Access Compliance Report

Public Rights-of-Way

| Intersection ID: 50940 | Main Street: BLAIRBETH_ST | Cross Street: ARDREY_KELL_RD | Location: NE |
| ADA ID: 5F5016D9254A | Ramp Type: Perp | Initial Pass/Fail: Fail | Overall Compliance: No |

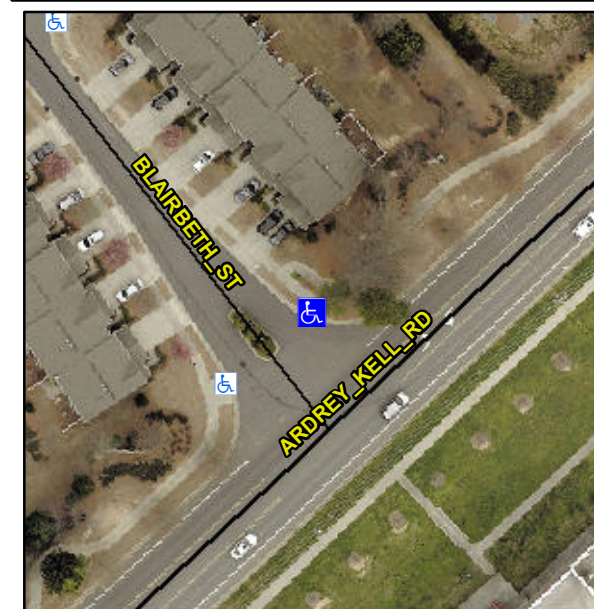
Not Found, R304.2.2

| Compliance | Description | Data | Compliance | Description | Data |
|------------|-----------------------|-------|------------|-----------------------------|------|
| N/A | Ramp Length (in) | 93.0 | No | Ramp Slope (%) | 10.3 |

Remove & Replace Entire Ramp.
